ADVISORY REPORT
FINDINGS, CONCLUSIONS, AND RECOMMENDATIONS

File: ZON18-00720 for Kirkland Shelter

3. Request: Construction of a 19,508 square foot shelter for women and families with children. Access will be provided by a 48.5-foot access and utility easement across parcel 123310-0170 (Salt House Church, 11920 NE 80th Street). Parking for the shelter will be shared with the Salt House Church, and available on-street parking along 120th Ave NE (see Attachment 2).

SITE PLAN

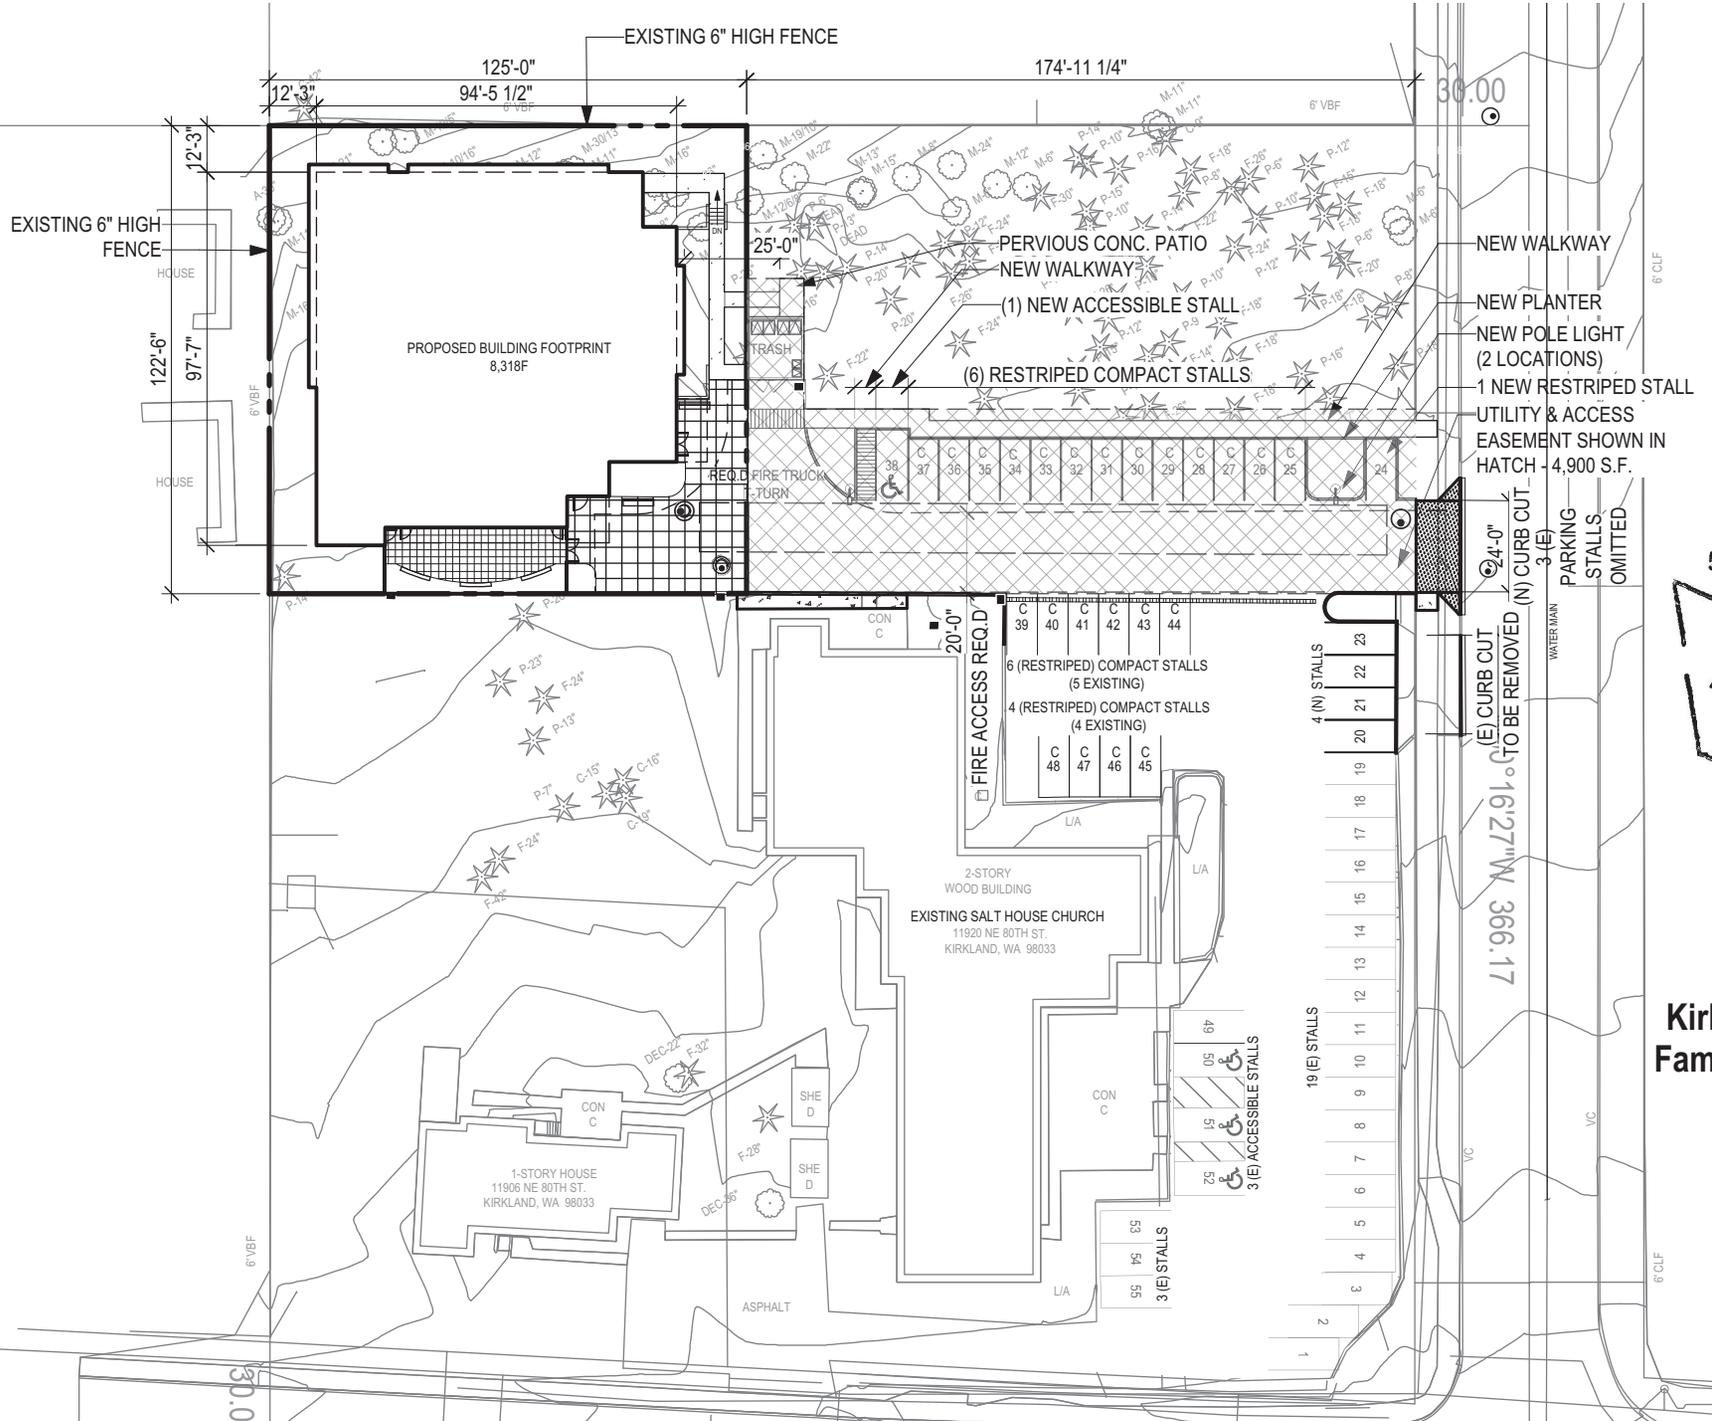
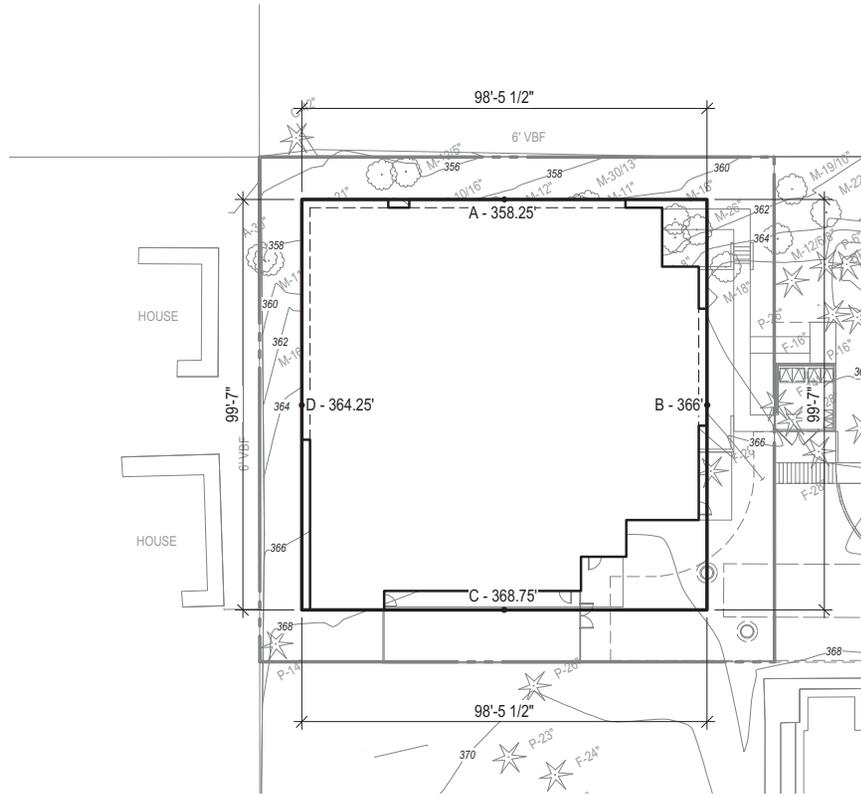
- (2) Over the primary exterior entrance to all buildings including residential units.
 - (4) The applicant's plan depicts a pedestrian access walkway 4.5 feet in width from the front property line for a distance of approximately 128 feet. The walkway then flares to 5 feet in width, leading to the structure's front door, which is covered by an awning extending 7'9" from the east facing front façade. The public pedestrian walkway, where it abuts parking spaces, will be separated from the parking by 6" vertical curbing (see Attachment 2).

- b. Provide a revised set of plans which depicts the pedestrian walkway as having a continuous width of 5 feet and a corresponding lighting plan (see Conclusion II.F.8.b(1-2)).

- b. Conclusion: The provision of vertical curbing between the parking spaces in the access easement and the walkway will serve to demarcate the two improvements and contribute to safe and secure public access. Prior to the issuance of the Land Surface Modification, the applicant should provide a revised site plan which depicts:

- (1) The walkway has a continuous width of 5 feet;
 - (2) A lighting plan for security and safety of pedestrians, with non-glare lights, scaled appropriately for the improvement;

TREE RETENTION PLAN

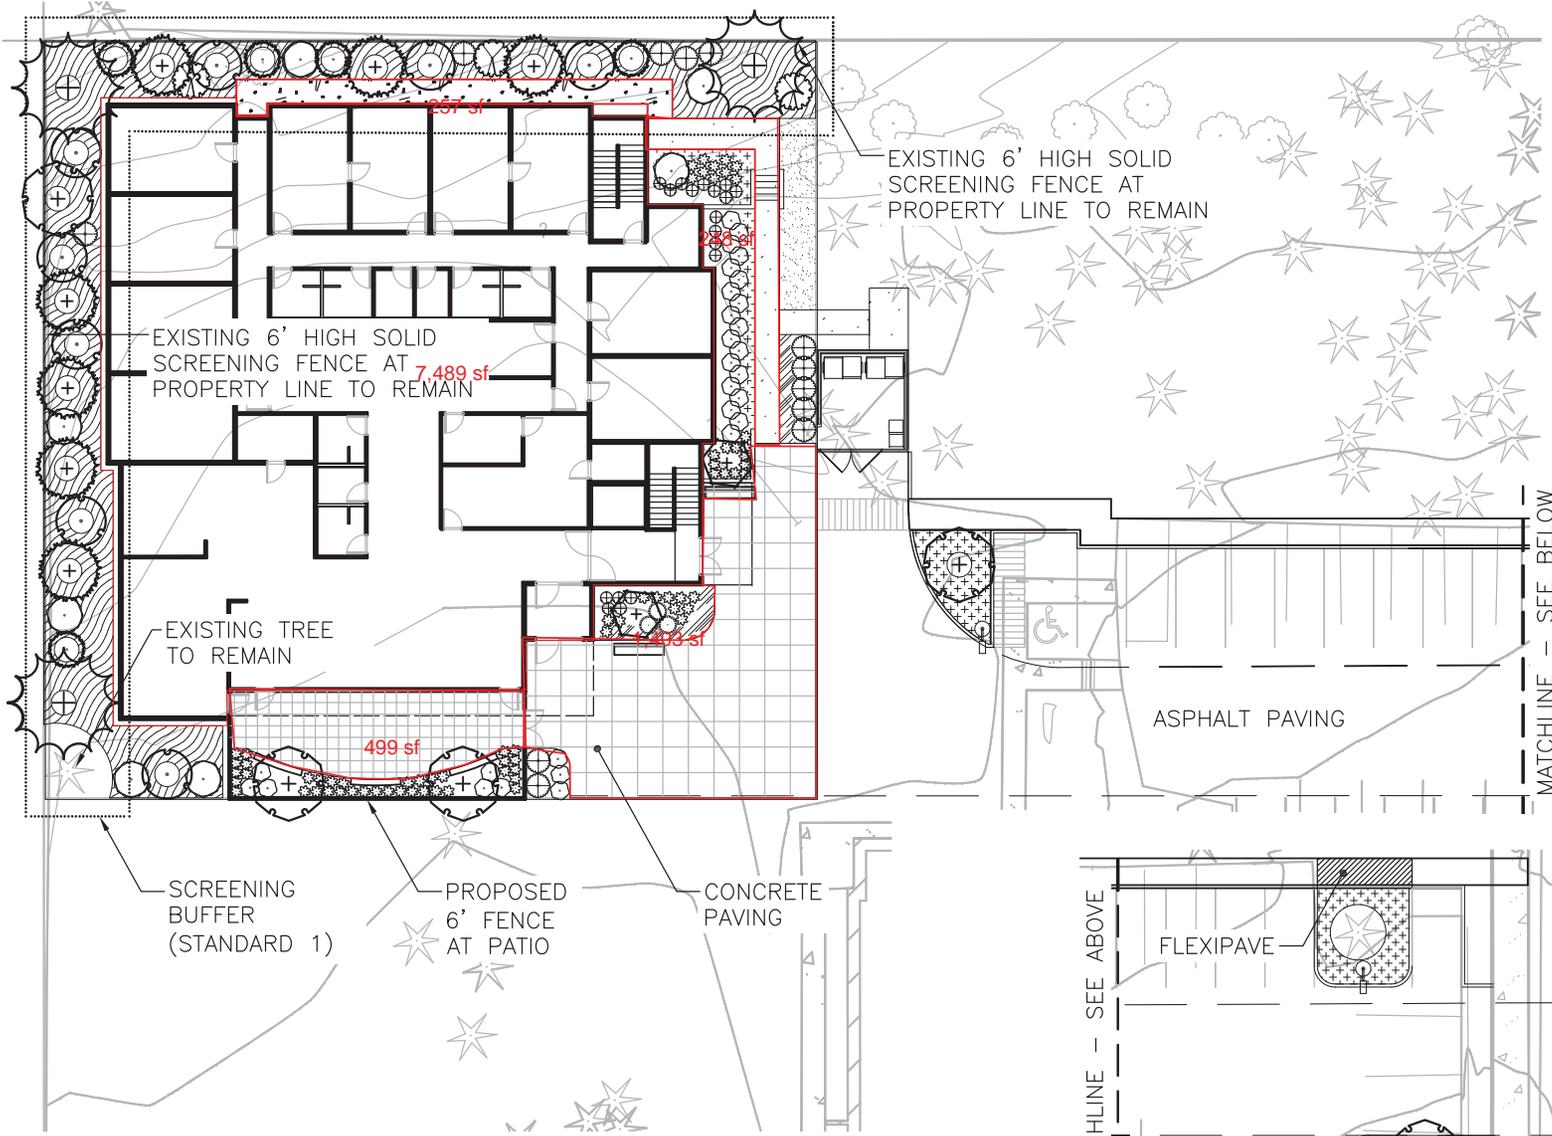
- (3) The City's Arborist has reviewed the Tree Plan and has provided the following comments:
 - (a) The proposed site plan does not accurately depict the Arborist report, both in proposed removals and tree numbering.

- (c) The plan set for the zoning permit does not identify limits of disturbance or appropriate tree fencing relative to those limits, based upon an assessment from the applicant's arborist.

- Update Tree Retention Plan and Landscape Plan (L1.0 & L2.0).
 - Add tree protection fencing at the limits of disturbance for all retained trees.
 - Add tree numbers from the attached table of trees and site map.

- Reassess removal of trees 962 and 963 if Utilities and Drainage Plan (C4.1 & C4.2) and the Landscape Plan (L2.0) are updated.
 - Sidewalk paving within the limits of disturbance should consist of Flexi-Pave®.

- c. Revise the site plan to reflect accurate tree numbers as reflected in the arborist report. (see Conclusion II.F.9.b(1)).

- d. Revise the site plan to accurately reflect trees recommended for removal by the applicant's arborist. (see Conclusion II.F.9.b(2)).
 - e. Provide a revised geotechnical report which provides the necessary quantitative analysis to support the conclusions reached in the AESI report dated January 29, 2019 (see Conclusion II.F.10.b(1)).

- b. Conclusions: Prior to the issuance of the Land Surface Modification permit, the applicant shall:
 - (1) Update the site plan to include accurate tree numbers as reflected in the arborist report.

- (2) Revise the site plan to accurately reflect the arborist's recommendation of trees to be removed.
10. Geologically Hazardous Areas
 - a. Facts:
 - (1) The City's Zoning Code Chapter 85 governs parcels located in geologically hazardous areas, as designated by the City of Kirkland, and/or identified by a qualified professional.
